Access Compliance Report

Public Rights-of-Way

(Curb Ramps)

Intersection ID: 30057	Main Street: SOUTHWIND_DR	Cross Street: SUNSET_VILLAGE_DR	Location: S
ADA ID: 7ADCC5D6ED34	Ramp Type: BlendTrans1	Initial Pass/Fail: Fail	Overall Compliance: No
Severity Score: 12.5			
Codes/Mitigation Info/Possible Solution		Field Measurements/Component Compliance

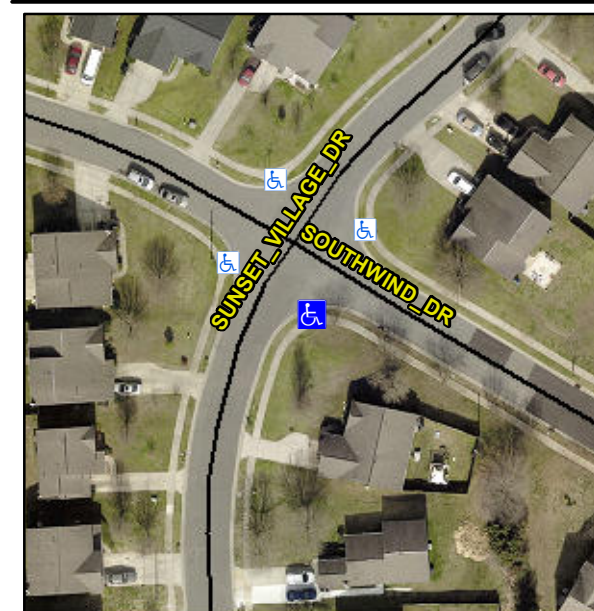
Not Found, R304.5.3

Compliance	Description	Data	Compliance	Description	Data
N/A	Ramp Length (in)	47.0	Yes	BlendTrans Slope (%)	4.8
Yes	Ramp Width (in)	48.0	No	BlendTrans XSlope (%)	6.8
N/A	Flare Type LT	N/A	N/A	Flare Type RT	N/A
N/A	Flare Slope LT (%)	N/A	N/A	Flare Slope RT (%)	N/A
N/A	Flare Traversable LT?	N/A	N/A	Flare Traversable RT?	N/A
N/A	Landing Length (in)	N/A	N/A	DWS Provided?	N/A
N/A	Landing Width (in)	N/A	N/A	DWS Contrast?	N/A
N/A	Landing Slope (%)	N/A	N/A	DWS Length (in)	N/A
N/A	Landing X Slope (%)	N/A	N/A	DWS Full Width?	N/A
N/A	Landing Curb? (Y/N)	N/A	N/A	DWS Offset (in)	N/A
N/A	Shared Landing?	N/A			
N/A	Gutter Ponding?	N/A	N/A	Gutter Slope (%)	N/A
N/A	Gutter Lip Ht (in)	N/A	N/A	Gutter X Slope (%)	N/A
N/A	Painted X Walk1?	No	N/A	Painted X Walk2?	No
	X Walk 1 Direction	To NE		X Walk 2 Direction	To NW
	X Walk 1 Width (in)	N/A		X Walk 2 Width (in)	N/A
	X Walk 1 Slope (%)	1.4		X Walk 2 Slope (%)	6.8
	X Walk 1 X Slope (%)	7.7		X Walk 2 X Slope (%)	0.4

N/A	Ramp inside XWalk1?	N/A	N/A	Ramp inside XWalk2?	N/A
	Road Slope (%)	6.0		Clear Space?	N/A
	Road X Slope (%)	3.4	N/A	Clear Space to XWalk (in)	N/A
N/A	Any Obstructions?	N/A	N/A	Storm Grate/Utility Hazard?	N/A
	Obstruction Type			Storm Grate/Utility Type	
		N/A			N/A
			Yes	Surface Condition? (G/P)	Good
			No	Curb Slope (%)	7.9

Remove & Replace Curb Ramp With Two New Directional Ramps or Equivalent.
